PETITION FOR VARIANCE APPLICATION

Name of Owner Sector67 Inc.	Project Description Second floor build out including an elevator and south side steel deck and exit stairway	Agent, architect, or engineering firm James Widder
Company (if applies)		No. & Street 3142 Lakeland Ave
No. & Street 56 Corry St	Tenant name (if any) Sector67 Inc.	City, State, Zip Code Madison, WI 53704
City, State, Zip Code Madison, WI 53704	Building Address 56 Corry St	Phone 1-612-481-4915
Phone 608-241-4605		Name of Contact Person James Widder
e-mail team@sector67.org		e-mail jamesrwidder@gmail.com

City of Madison Fire Department Position Statement

Meeting Minutes - Approved BUILDING CODE, FIRE CODE, CONVEYANCE CODE AND LICENSING APPEALS BOARD

DWG. TITLE
SITE PLAN

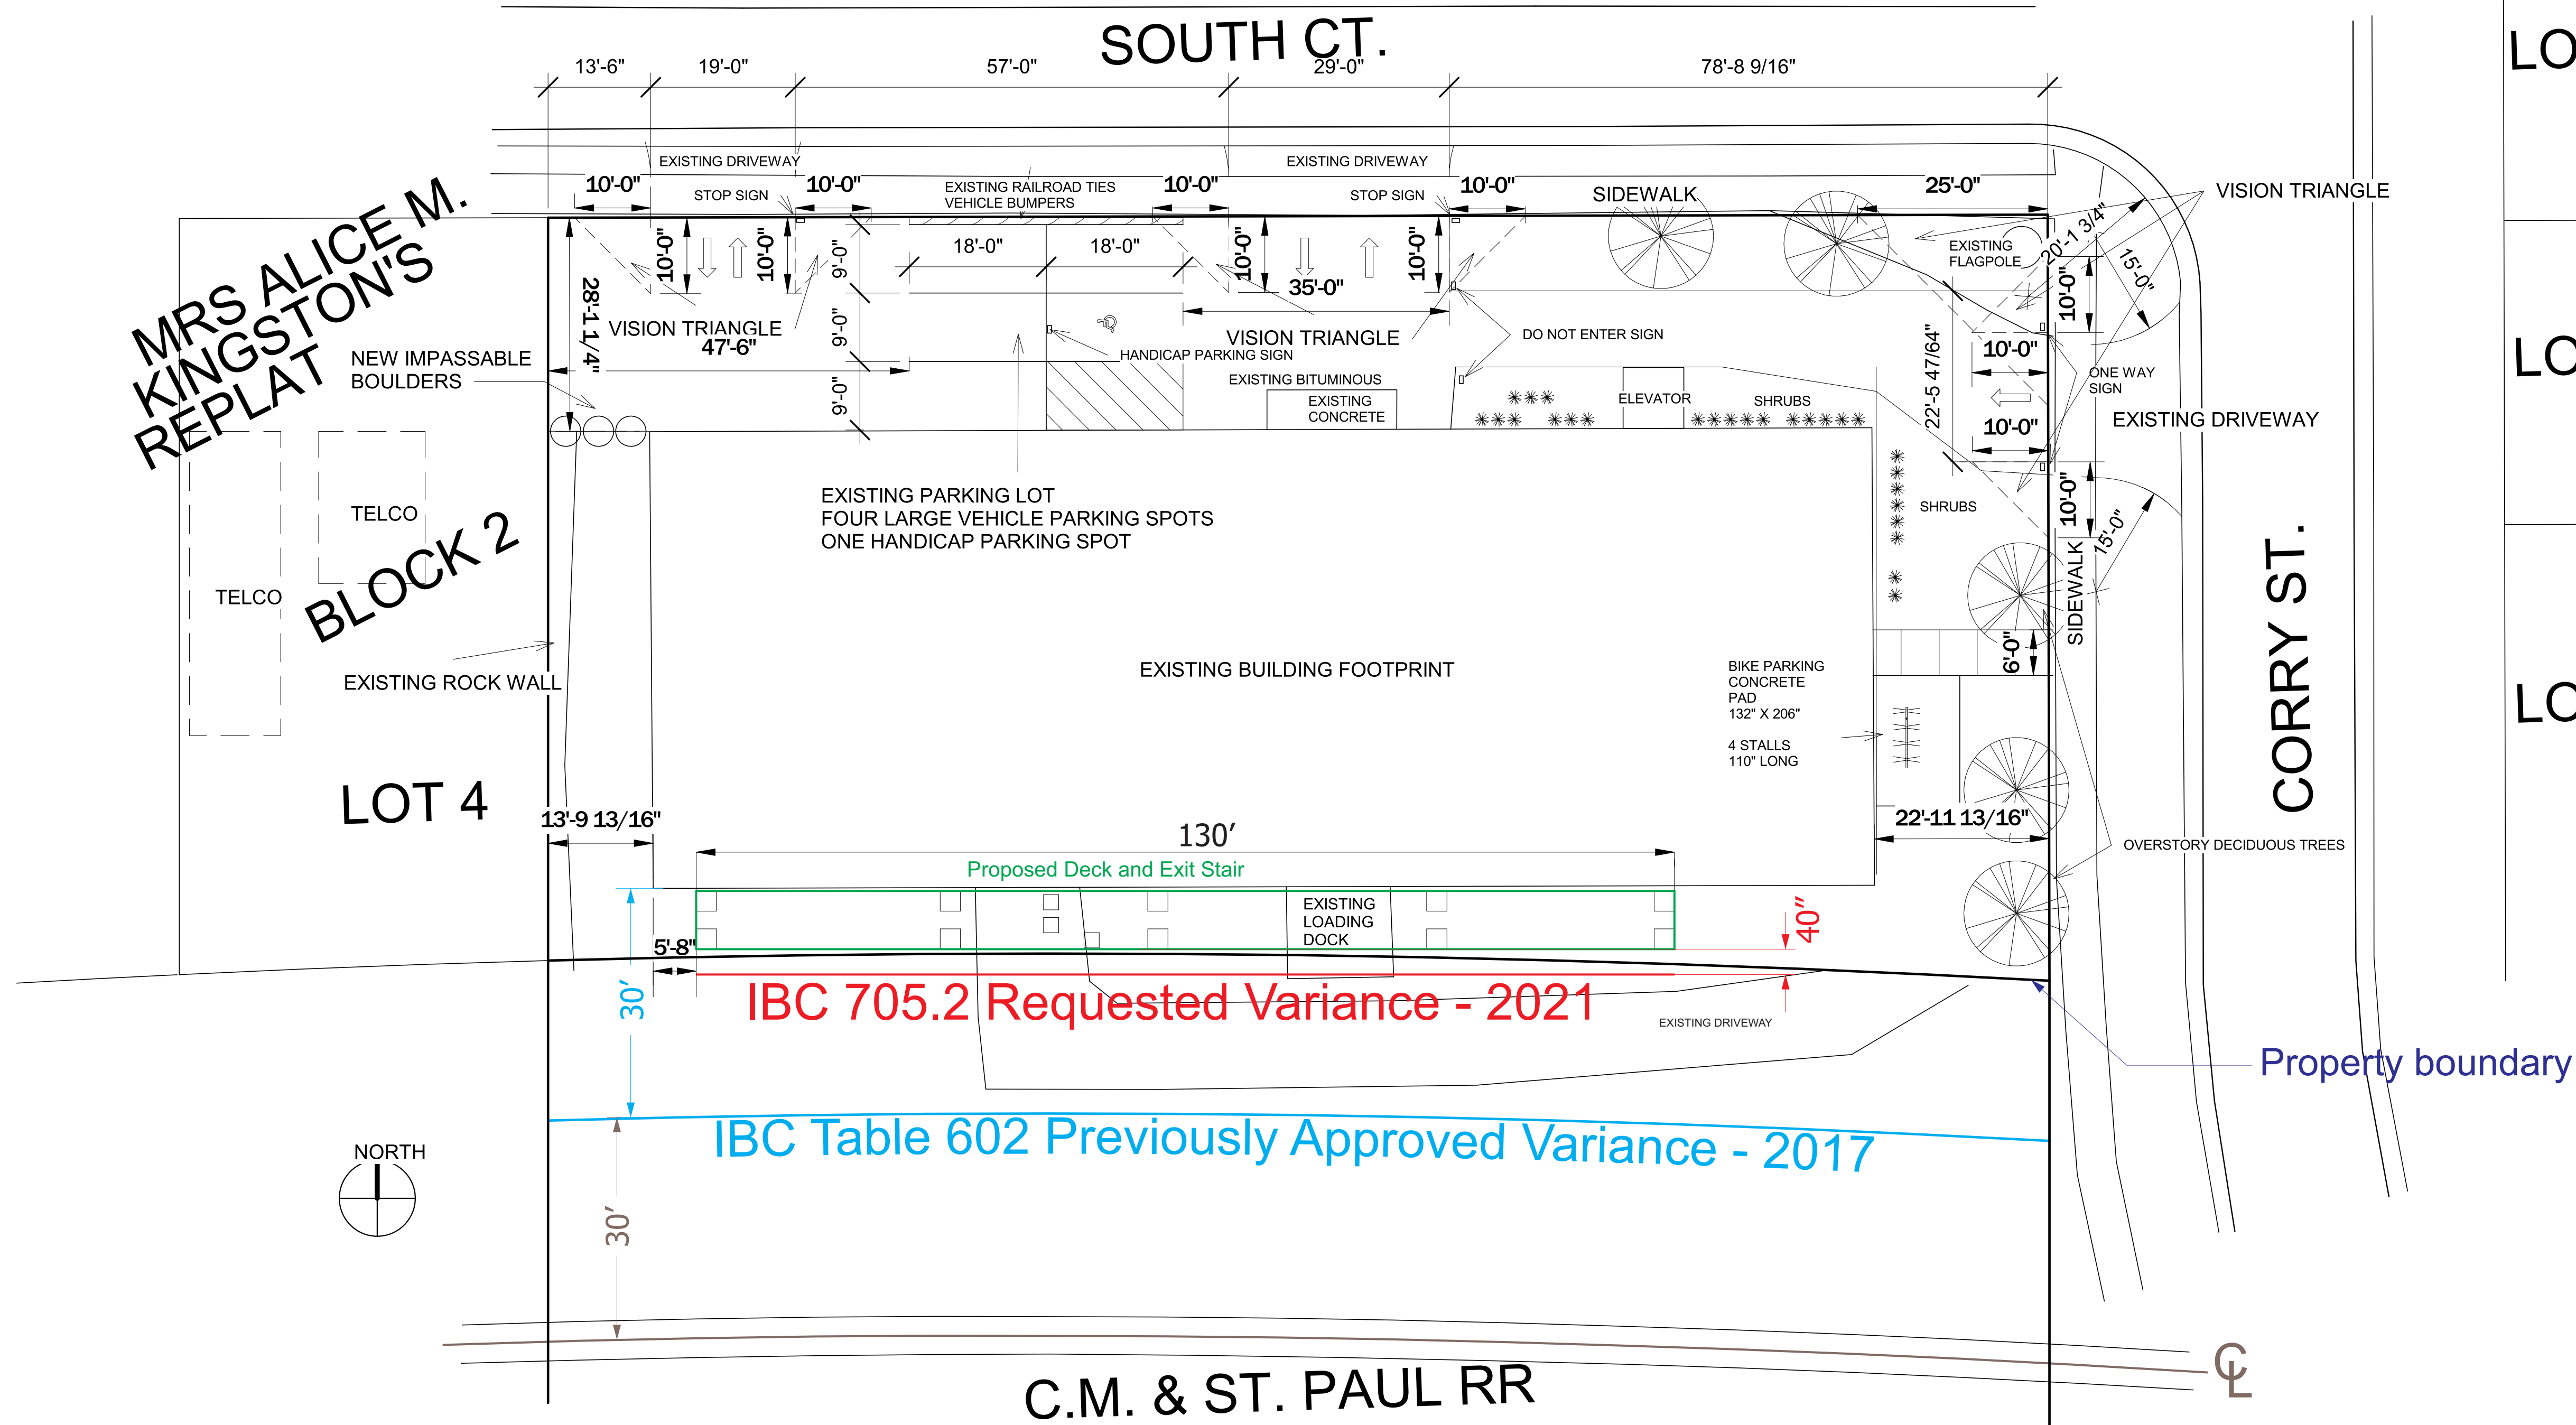
1. The rule being petitioned reads as follows: (Cite the specific rule number and language. Also, indicate the nonconforming conditions for your project.)
 "IBC 705.2 The new open stair and deck shall not project closer than 40 inches to the property line for fire separation distance."

The proposed construction includes all steel 2nd floor deck with steel stairs to grade. Our renovated 1949 building is located 8'9" to 11 feet from our southern property line along the railroad tracks, the deck is 8 feet wide which would require 4" to 31" of variance.

If we include a 40 inch setback from the property line then the deck becomes too narrow to allow for a staircase and passing width to use it from both ends of the building.

Our building has been in place since it was constructed in 1949. In 1959 the south side of the building had 100 feet of 12 foot deep awning installed and in 1965 a 13' x 13' concrete loading dock was poured to provide grade access to a garage door. The prior building owners have all made functional use of this property considering the railroad setback to be non-buildable. In 2017 to support our initial renovation plans we received a building code variance waiving south side fire setback which allowed us to increase our southern window area and remove the requirement of a 1 hour fire rated south side wall. The current variance request falls well within the 2017 variance setback. While not required by code, the proposed deck and staircase greatly improve egress from our second floor in the event of an emergency and provide readily accessible outdoor air to escape from any indoor hazard. The Wisconsin DOT has previously stated the railroad right of way is required for railroad operation and should be considered non-buildable clear space needed for railroad operations (e-mail correspondence enclosed with this application). No part of the building or proposed construction will project past our property boundaries.

- Applicant was asked to address the distance to the property line to the South which is along the railroad corridor. In the past, the Dept of Transportation wanted to maintain their property as buildable for various types of structures. MFD supports the design using the rail line as a public way based on the email from the Dept of Transportation agreeing to such.
- The deck shall be removed or other modifications to bring it into compliance with the applicable building code at any time in the future that the DOT chooses to modify the use of their property other than on open rail corridor.
